Product Change Notification / ASER-15CAKZ286

CCB 4630.001 Final Notice: Qualification of STA as an additional assembly site for selected CAP1188 and USB33xx device families available in 24L VQFN (4x4x0.9mm) package.

Pre and Post Change Summary

PCN #: ASER-15CAKZ286

Lead frame Comparison

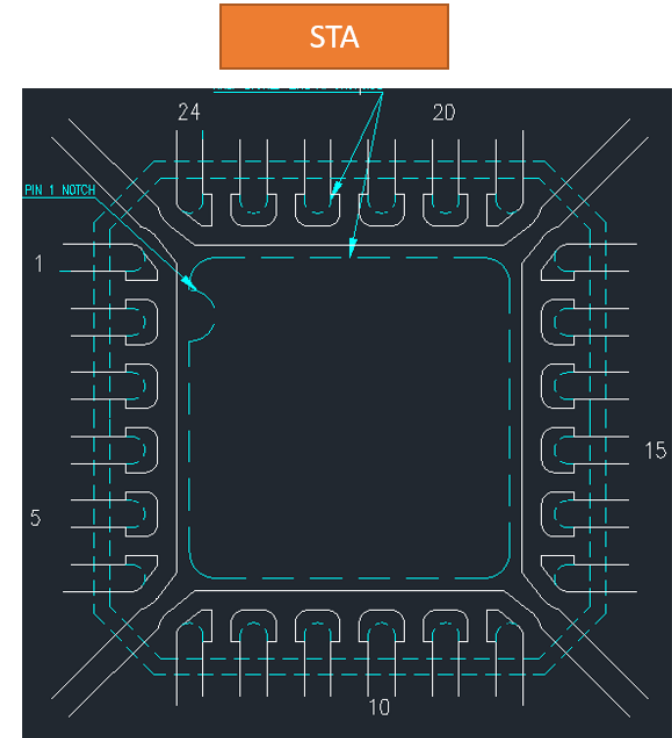
Assembly Site	ASE Inc. (ASE)		ASE Inc. (ASE)		STATS Chippac Ltd. (STA)
Wire Material	PdCu	Au	PdCu	Au	CuPdAu
Die Attach Material	EN-4900F		EN-4900F		8290
Molding Compound Material	G631B		G631B		G700E
Lead-Frame Material	C194		C194		C194
	See Pre and Post Change Summary for comparison.
